Re: **Two 6,000-SF Warehouse Building**
280 NYS Route 67
Town of Amsterdam
Project # 5589A

In response to Delaware Engineering, D.P.C. comments (in *italics*) provided to us in a memo dated February 3, 2026 regarding the two (2) 6,000 SF Warehouse Building Site Plan review located at 280 NYS Route 67 we respectively respond as follows (in **bold**):

BUILDING ELEVATIONS
MANNY CORNERS WAREHOUSE
280 NYS ROUTE 67

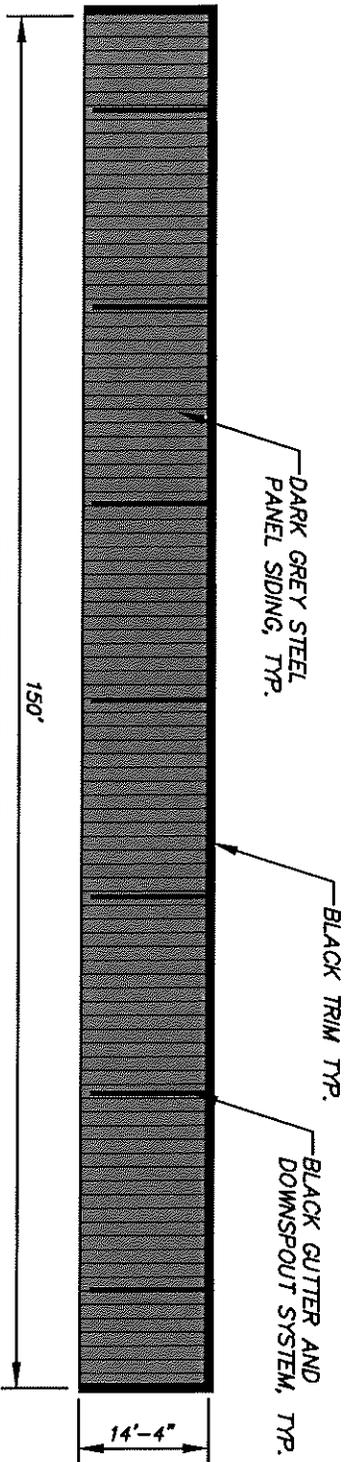
- c. *Pursuant to Art. VI Section 20(5)(C)(22) elevation plans at a scale of $\frac{1}{4}'' = 1'$ for all exterior facades of the proposed structure(s) and/or existing facades, plus addition(s) showing design features and indicating the type and color of materials to be used.*

**FIRE TRUCK MANEUVERING EXHIBIT
MANNY CORNERS WAREHOUSE
280 NYS ROUTE 67**

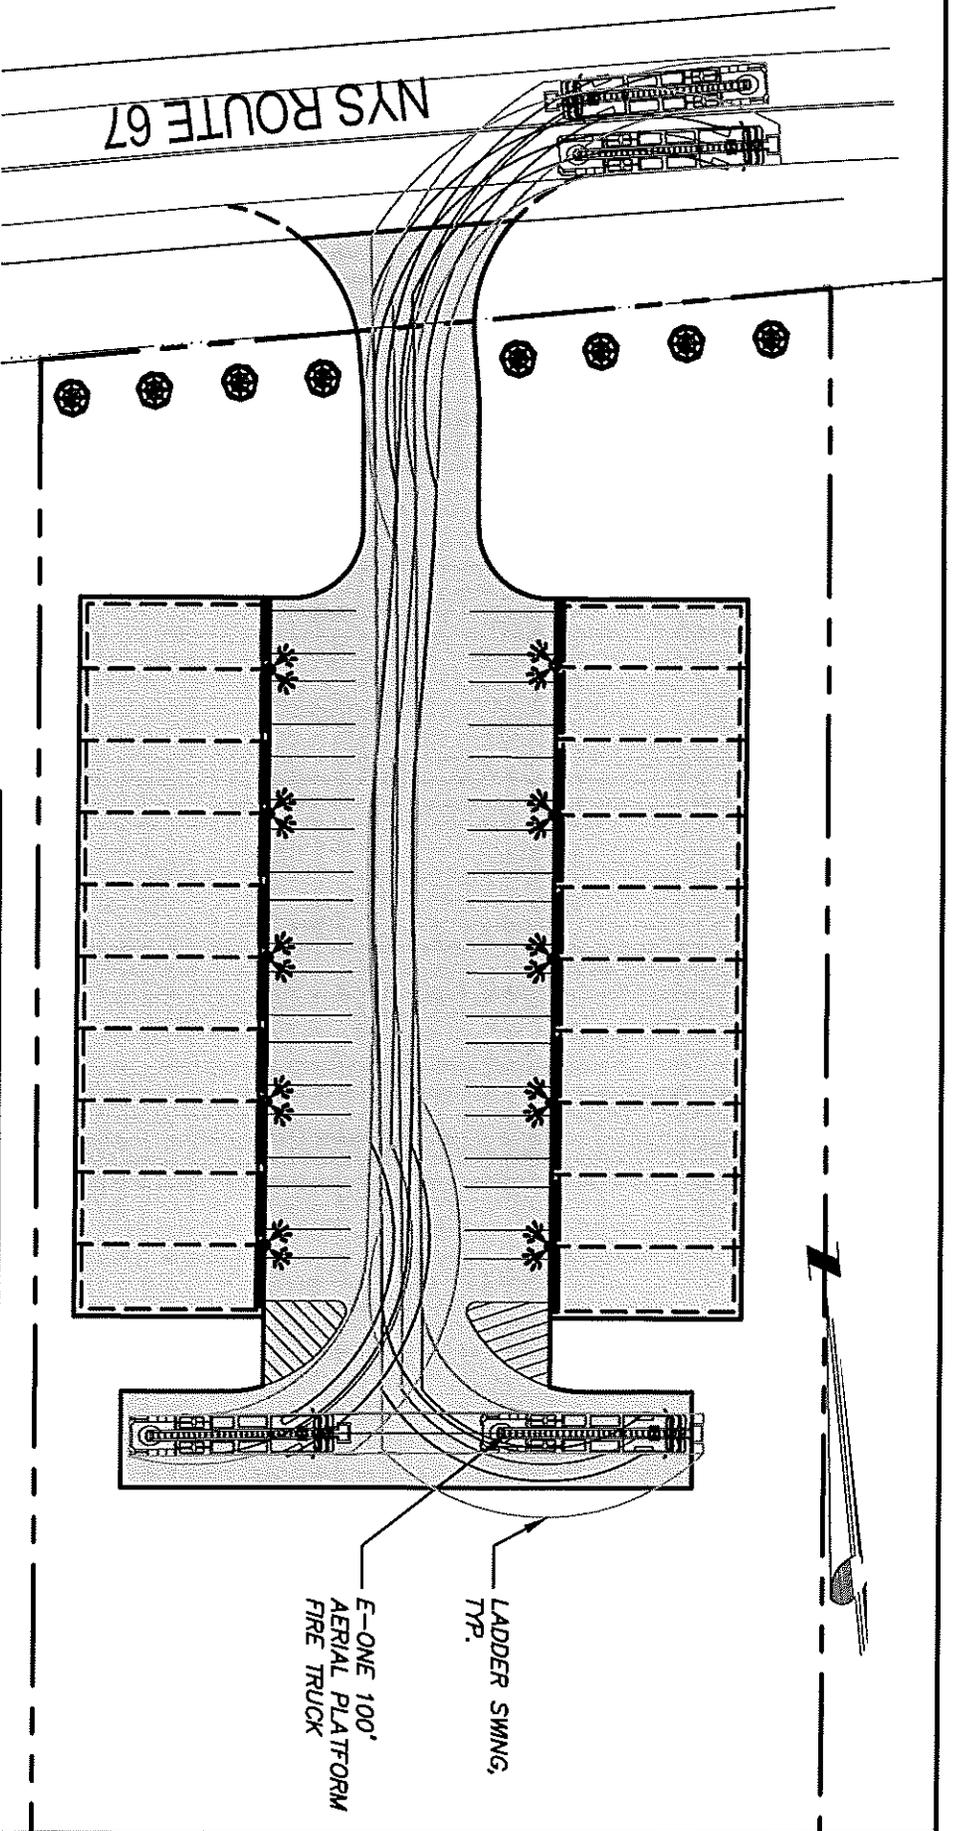
- d. *The project requires provision of an approved fire apparatus access road and involves a dead-end in excess of 150'. Unless modified by the fire code official (e.g., under provisions for dead-end access roads for an unoccupied use category), a fire apparatus turnaround must be provided in accordance with the fire code of NYS.*

A "T" turnaround in compliance with NYSEC is provided on the plan. A Fire truck turning exhibit is also included with this submission. Also, please note that plans have been sent to the Cranesville Fire Department for their input.

EVERGREEN TREE PLANTING DETAIL
NO SCALE

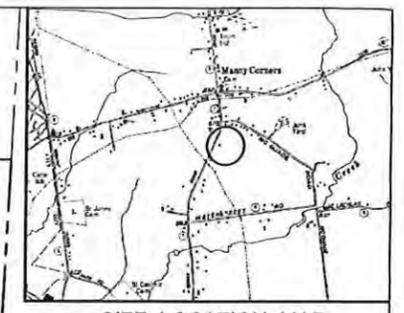
- f. *Ground disturbance is required in order to install the proposed 8 tree plantings. A planting detail must be provided and the limits of disturbance revised accordingly. In addition, the method of connecting to public utilities should be confirmed and, if underground, a trenching detail supplied and the limits of disturbance revised, as appropriate.*

The ground disturbance for the trees are minimal, but have been included in the disturbance calculations.

DUAL-HEAD DUSK-TO-DAWN LED OUTDOOR SECURITY LIGHT DETAIL
NO SCALE

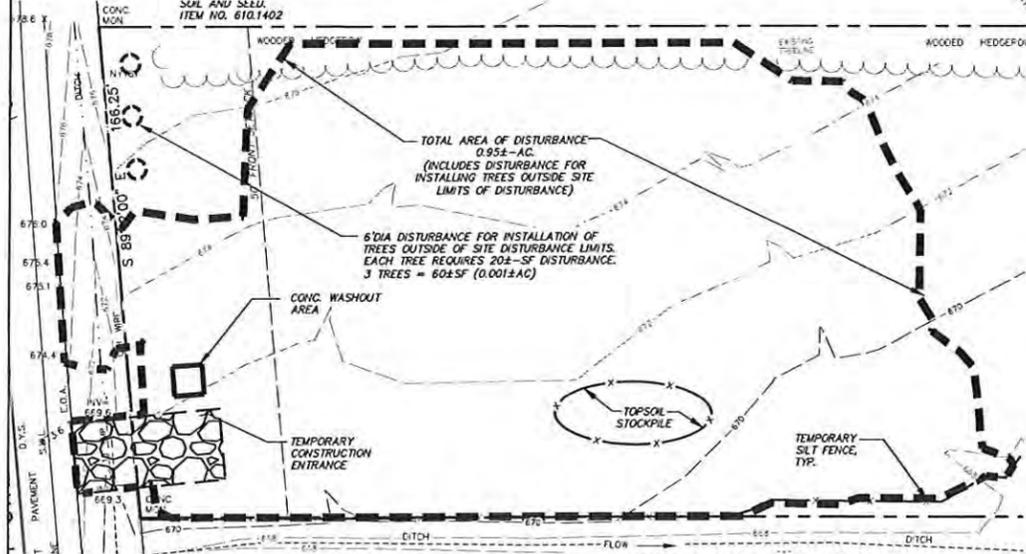
h. *There are 10 floodlight-type lighting fixtures proposed. Site plan notes indicate that these are to be "down mounted." The associated detail should be updated to reflect the angle required to achieve the proposed down mounting. In addition, the lighting does not appear to be shielded, nor does the detail include information for the Board to determine intensity (see Special Use Permit criteria Art. VII Section 21(3)(D)).*
Flood light shields are called out on the detail as well as down mounting angle.

- NOTE:**
1. LIGHTS TO BE DOWN MOUNTED FACING @ A 22" MAX. ANGLE
